Re: Perry Nuclear Power Plant
IE Bulletin Nos. 79-02, 79-02 Rev. 1

PERRY NUCLEAR POWER PLANT
UNIT 1 & 2
NRC IE BULLETIN 79-02 (REV. 1)

A detailed review was performed in response to the United States Nuclear Regulatory Commission (NRC) request, IE Bulletin No. 72-02 (Rev. 1) - "Pipe Support Base Plate Design Using Concrete Expansion Anchor Bolts", dated June 21, 1979 for Perry Nuclear Power Plant Unit 1&2, Docket Nos. 50-440 and 50-441. The review was performed on a representative sample of safety-related supports (Seismic Category I). Possible effects of base plate flexibility on base plate anchors were considered. This report presents the methods and results of the review.

FIGURE 1

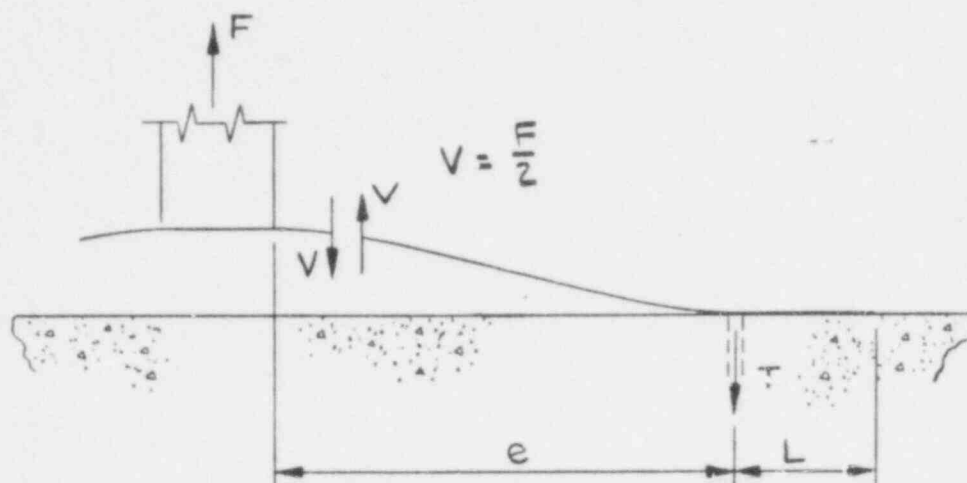
Verify that pipe support base plate flexibility was accounted for in the calculation of anchor bolt loads. In lieu of supporting analysis justifying the assumption of rigidity, the base plates should be considered flexible if the unstiffened distance between the member welded to the plate and the edge of the base plate is greater than twice the thickness of the plate. It is recognized that this criterion is conservative. Less conservative acceptance criteria must

be justified and the justification submitted as part of the response to the Bulletin. If the base plate is determined to be flexible, then recalculate the bolt loads using an appropriate analysis. If possible, this is to be done prior to seating of anchor bolts. These calculated bolt loads are referred to hereafter as the bolt design loads. A description of the analytical model used to verify that pipe support base plate flexibility is accounted for in the calculation of anchor bolt loads is to be submitted with your response to the Bulletin.

Base plates were considered rigid in the original design. For re-examination of the base plates considering plate flexibility, procedures were developed for the analysis of the plates and anchorages for moment and axial load applied to the plate surfaces. (Figures 1, 2, 3, and 4)

Based on the plate and anchor response as described above, procedures were developed to determine tensile forces in the anchors, as shown in Figures 1, 2, 3 and 4. Shear and tension effects were combined

WHEN $(T_A - V)L = V\frac{e}{2}$, ANCHOR LOAD $T = T_A = \text{PRELOAD IN THE ANCHOR}$
